SUBJECT: CATAWBA NUCLEAR STATION - TIA 95-10, STANDBY NUCLEAR SERVICE
WATER POND ANALYSIS MODEL (TAC M95256 AND M95257)

SAFETY EVALUATION BY THE
OFFICE OF NUCLEAR MATERIAL SAFETY AND SAFEGUARDS
CATAWBA STANDBY NUCLEAR SERVICE WATER POND
DOCKET NOS. 50-413 AND 50-414

Figure 1 - Catawba Nuclear Service Water Pond

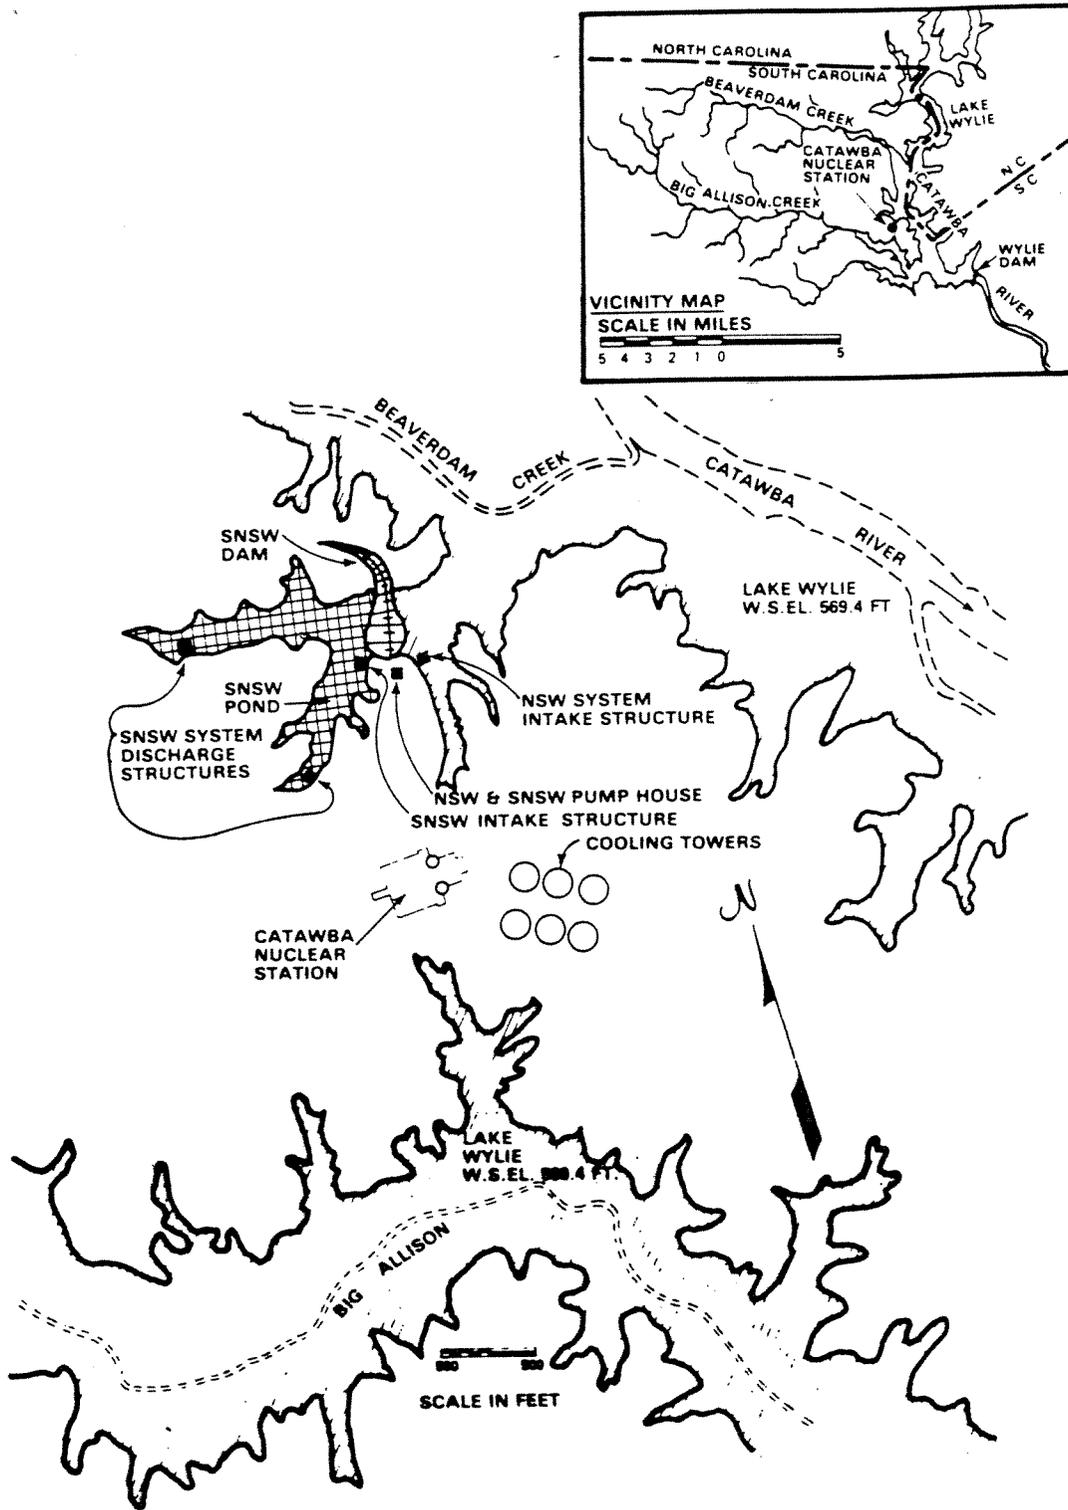
The Catawba Standby Nuclear Service Water Pond (SNSWP), shown in Figure 1, is an essential part of the ultimate heat sink (UHS) for the Catawba Nuclear Station, providing a back-up water supply in the event of a failure of the supply from Lake Wylie. The pond consists of a small impoundment of Lake Wylie, with two surface thermal outfalls and a single submerged intake. The pond must be capable of supplying cooling water below 92°F for up to 12.5 hours, and below 100°F for 30 days.

Figure 3 - Comparison of Meteorological Data from Charlotte N.C. and Catawba Site, Dew Point Temperature

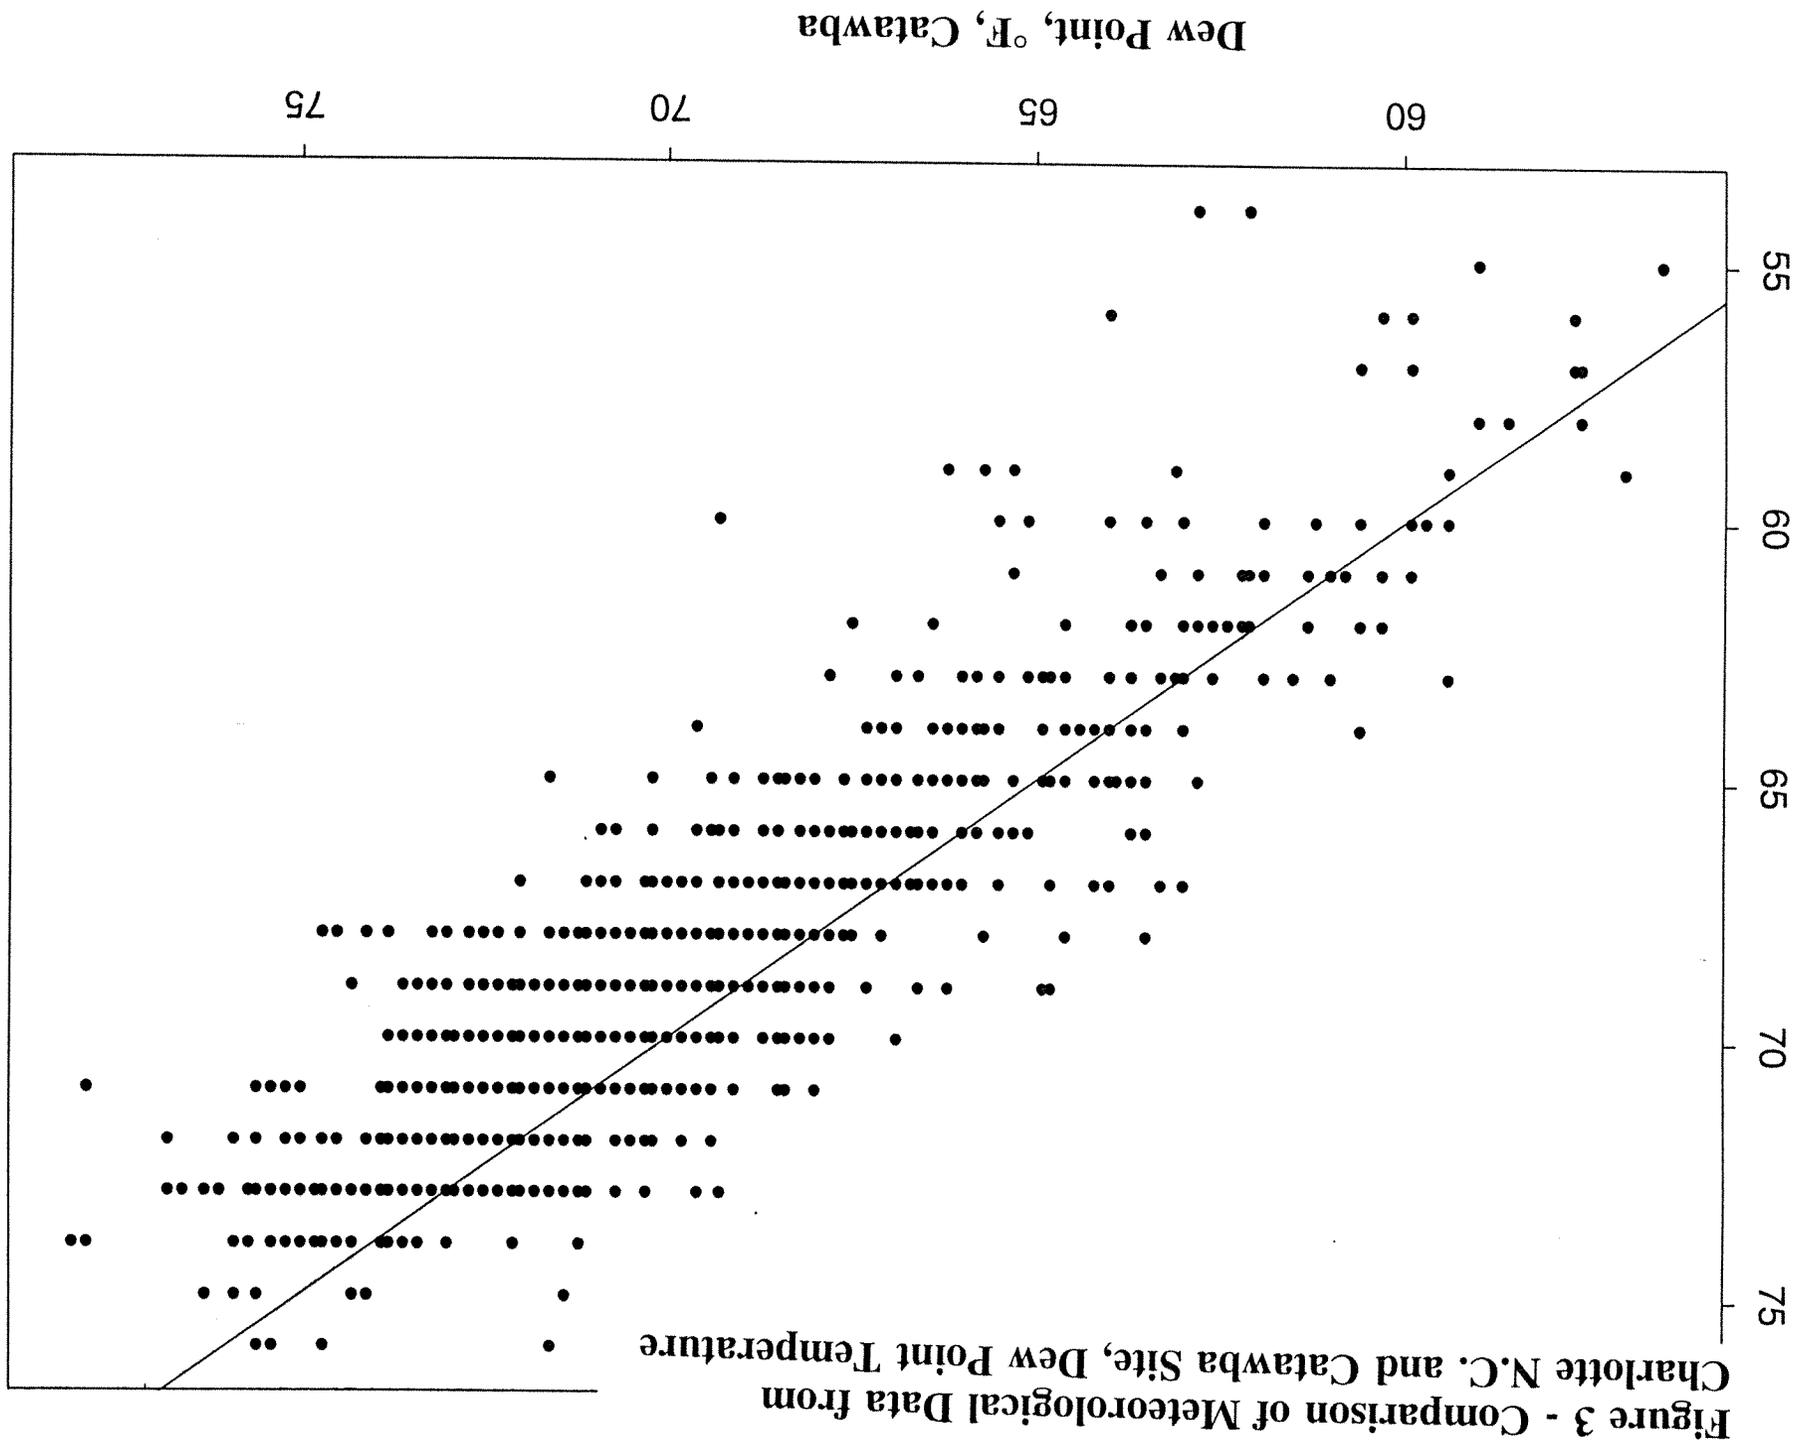
An approximately 10-year record existed for on-site meteorological data. In a telephone conference with Duke Power held on August 27, 1996, the staff requested this data for a comparison an offsite record from the airport in Charlotte, North Carolina. The licensee provided only dew point and dry bulb temperature. Comparison of coincident temperatures for the airport and Catawba site are shown in Figures 3 and 4 respectively. There is a clear bias in the dew point data, with higher values coming mainly from the Catawba site. The higher dew point probably can be explained by the proximity of Lake Wylie, which receives the thermal discharges from the plant. There is a less distinct difference in the dry bulb temperatures. On the basis of these correlations, the staff added 1.1°F and 0.1°F to the dew point and dry bulb

temperatures from the airport data, respectively (the average differences between the airport and site data). The licensee did not provide data on wind speed and solar radiation, so there were no corrections made for these parameters. The effects of the differences in any of the parameters appears to be minor.

Figure 5 - Measured Pond Temperature

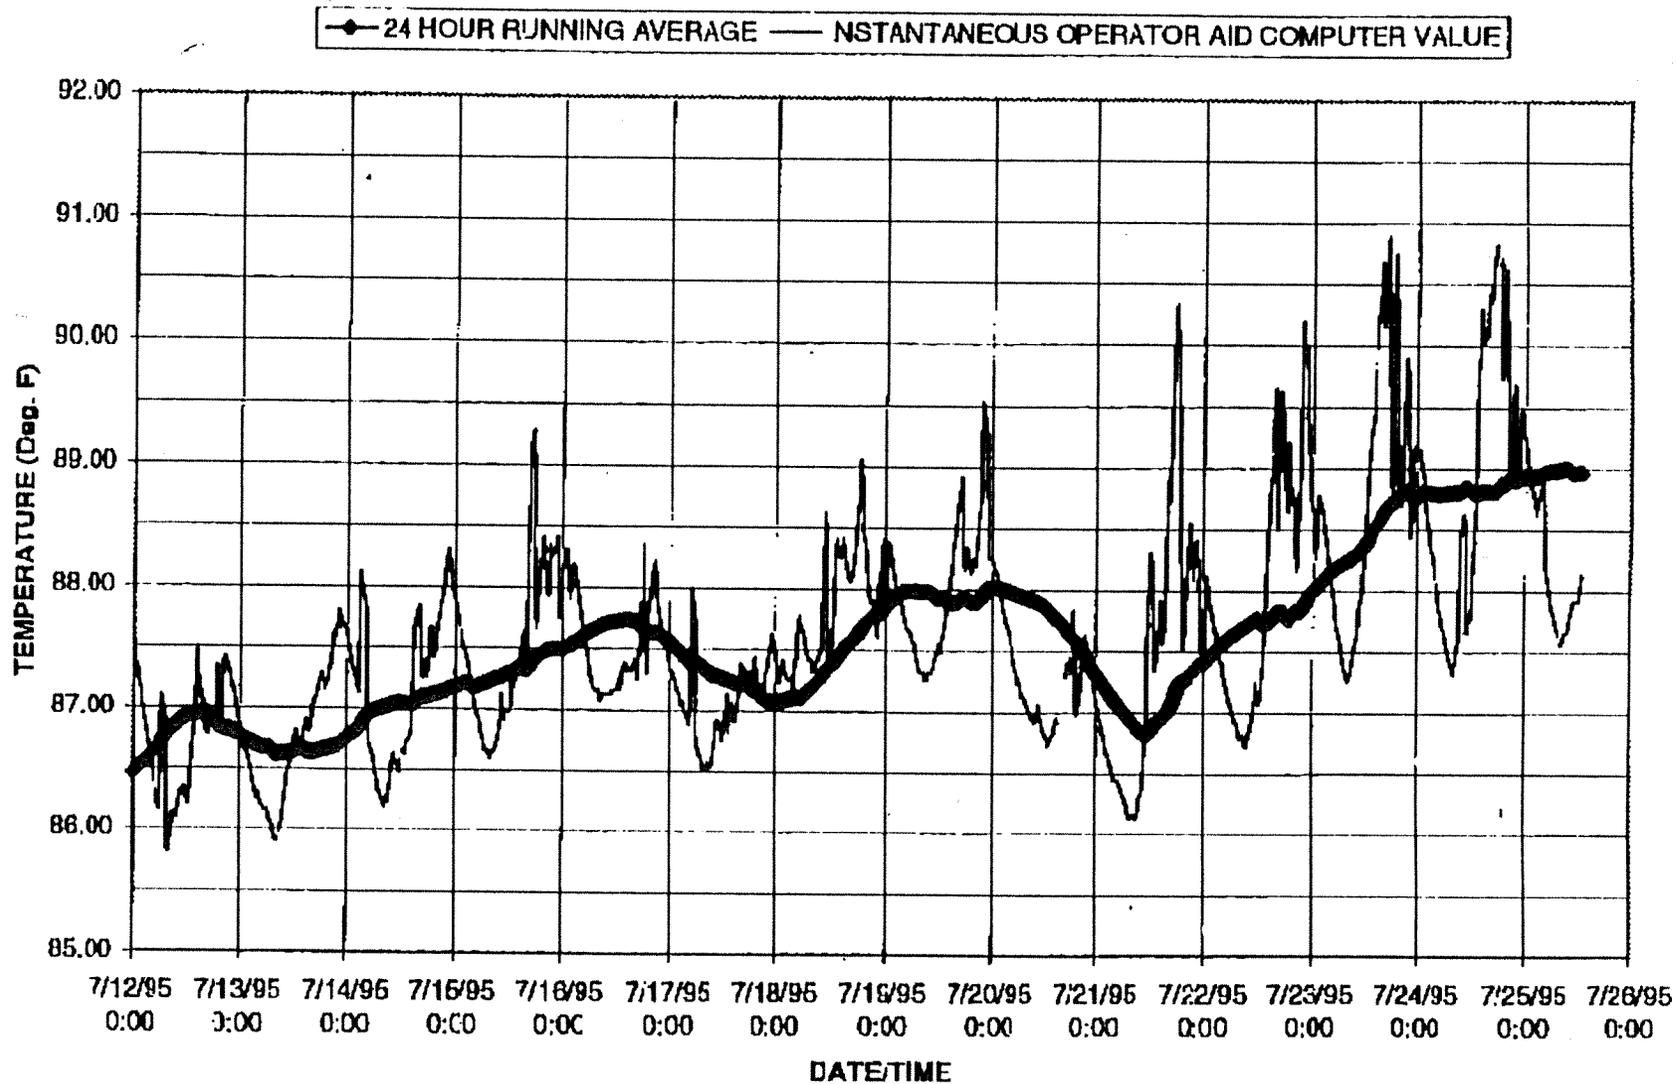
It is interesting to note that the peak unloaded temperatures for a totally mixed pond calculated with the CATU2 model was about 89.6°F. Figure 5 shows measured pond temperatures for the pond in July 1995. The measurement station was not indicated in the figure, but is probably a near-surface location based on the obvious diurnal variations. Figure 2 shows the strong pond stratification for summer months, indicating that there would be high stability and little vertical mixing during this period in the absence of flow. Running the model with the same meteorological data for a shallower

pond to simulate a stratified surface layer showed, as expected, a greater peak temperature; i.e., 89.6°F for a 10 foot thickness, 92.8°F for a 4 foot thickness and 95.5°F for a 2 foot thickness. The model results are qualitatively similar to temperatures observed in the field.

Figure 6 - Heat Load for Catawba UHS Analysis

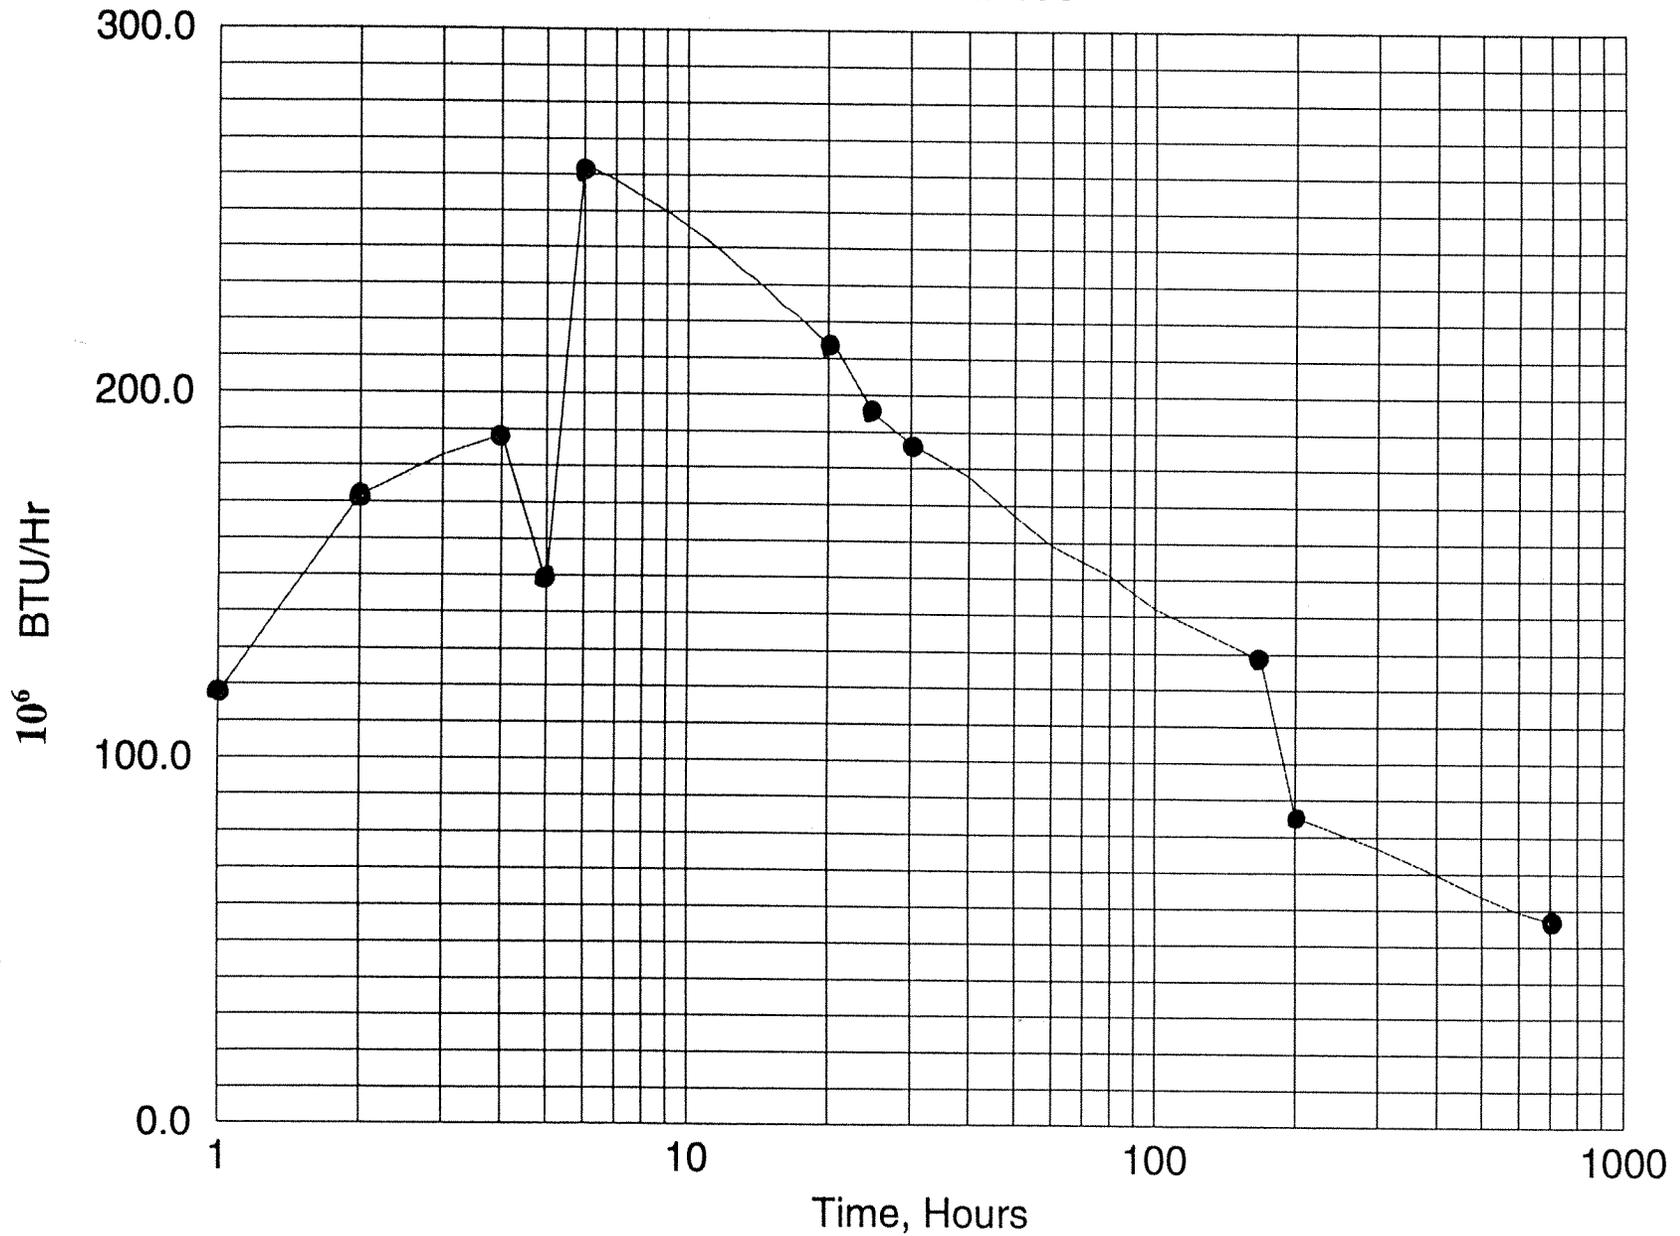
The pond models were run with 100 percent of the heat load and flow rate, for the 60-day period centered on 12:00 P.M., July 28, 1977, determined from the initial screening of the meteorological data. The 100-percent heat load curve is shown in Figure 6. Initial pond volume was 1.89×10^7 ft³, with constant pond surface area 1.65×10^6 ft². The model was run numerous times, with the starting time changed in 4-hour increments in order to align the peak meteorology and heat load timing, and the highest temperature for each of the three models (mixed, stratified or plug flow) was chosen from all runs.
